A14 Cambridge to Huntingdon improvement scheme

Statement of Common Ground between Highways England and Hilton Parish Council

Reference: HE/A14/EX/98/PC11

Version: Examination deadline 10

6 Appendix B – Bridge height requirements

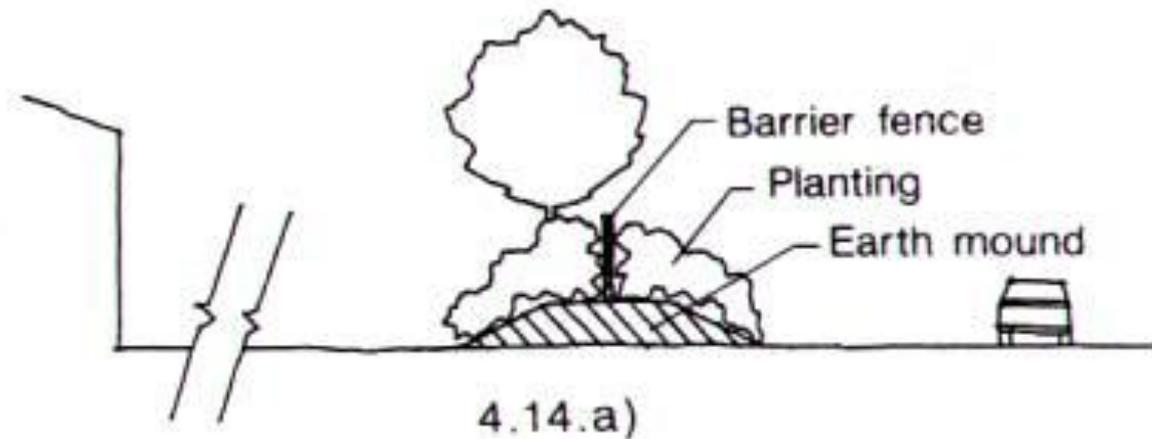
| 4 | Design and Engineering Standards Height of overbridges | Clarification is required on actual height of bridges above existing ground level. The Potton Road and Hilton Road bridges appear to be up to 2 | There is scope for refinement at detailed design stage when exact structural options are determined. There will be opportunity for consultation | Under discussion. |

| | | <p>metres higher than what is actually required with Potton Road at 11m; and Hilton Road bridge at 10.7m. More detailed engineering drawings are required and engagement at the detailed design stage.</p> <p>Highways England subsequently stated the additional height is due to the single span of the bridge across all six lanes with no central support.</p> | <p>and engagement during detailed design stage, at which stage there will be opportunities to comment on designs.</p> <p>At detailed design the elevation of side roads crossings will be minimised to reduce both impacts and costs. Please refer to Appendix B.</p> <p>In the meantime we will continue to discuss the height and appearance of structures with you.</p> | |

The typical height of an overbridge is 11.2 metres above ground level, this height is a summation of the following requirements:

1. The height of the mainline above ground level is driven by drainage requirements;
2. A 5.3 - 5.7 metre headroom is required under the bridge to accord with design standards (this depends on the structures impact resistance, so the scheme uses 5.7 metre structure to keep structure options open);
3. A structural depth of 2.0 metres is typically required (dependent upon the structure type and span);
4. Allowance for construction on bridge;
5. Allowances for road crossfall, gradient, construction and settlement etc.

- $3\text{m} + 5.7\text{m} + 2\text{m} + 0.5\text{m} = 11.2\text{ metres above ground level.}$
